- 3) Business Items**
 - a) **SITE PLAN REVIEW:** Application from David Lau on behalf of Woodland Cove, LLC for a site plan review of a 5,000 sq. ft. commercial building in Woodland Cove on Outlot F, Woodland Cove 3rd Addition; PID# 34-117-24-33-0052; PUD – Planned Unit Development.

Subject: SITE PLAN REVIEW: Application from David Lau on behalf of Woodland Cove, LLC for a site plan review of a 5,000 sq. ft. commercial building in Woodland Cove.

WOODLAND COVE OUTLOT F MINNETRISTA, MINNESOTA

SITE PLAN REVIEW/ PRELIMINARY PLAT

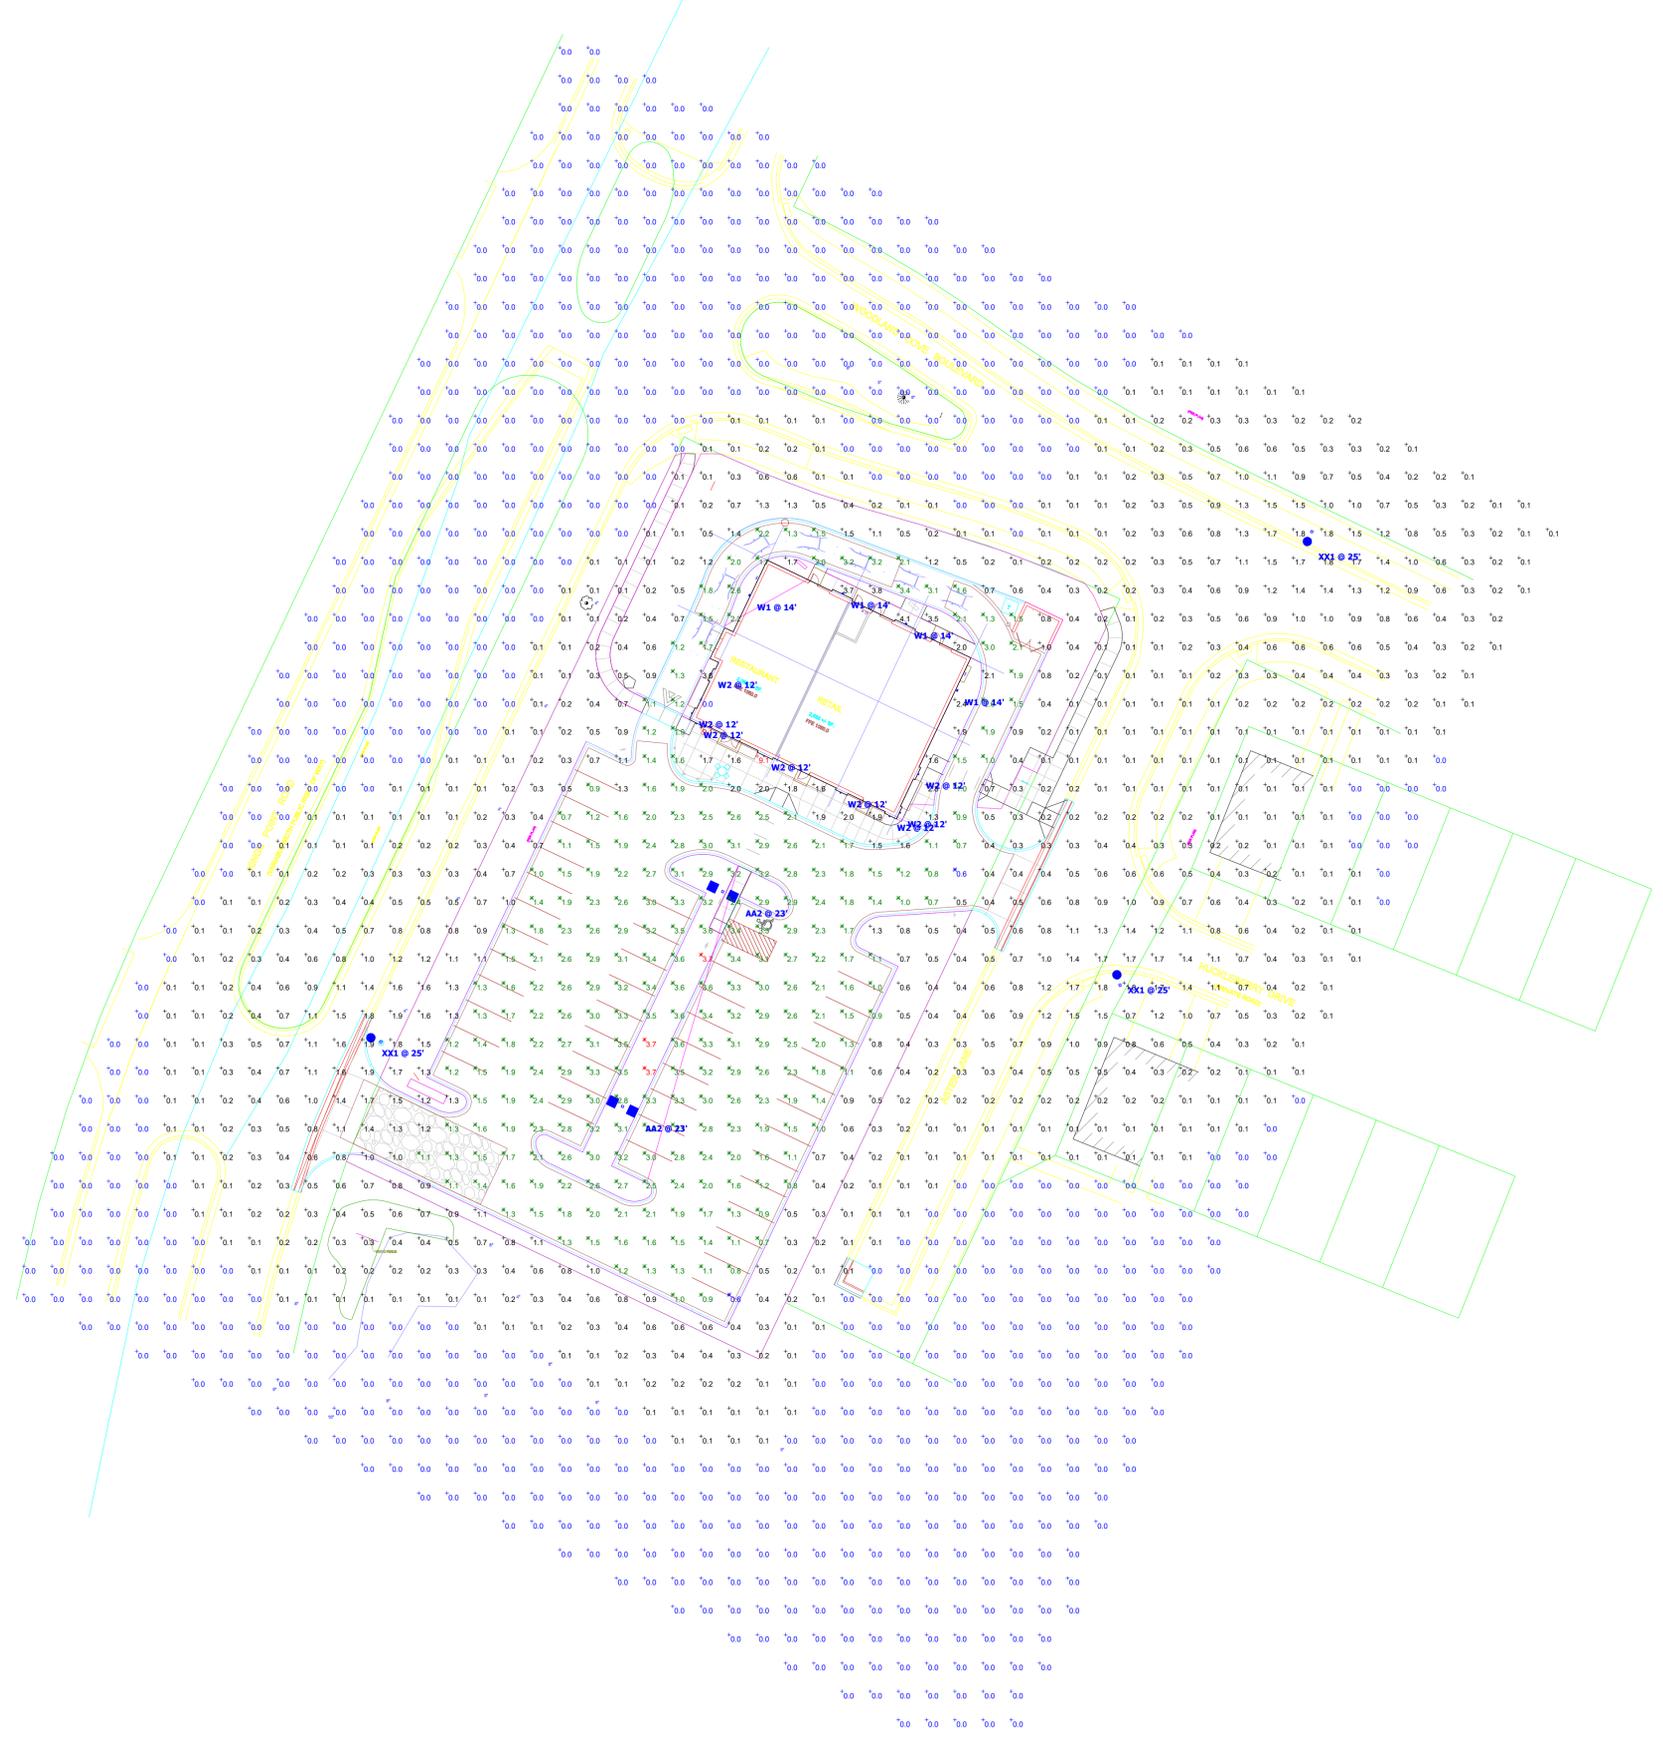
2. Provide an exhibit showing that intersection sight distance requirements are met at the new site access along Kings Point Road.
3. Include existing/relocated light poles on Kings Point Road, Woodland Cove, and Aster Lane on the photometric plan.
4. Provide turning movements for anticipated garbage and delivery vehicles.
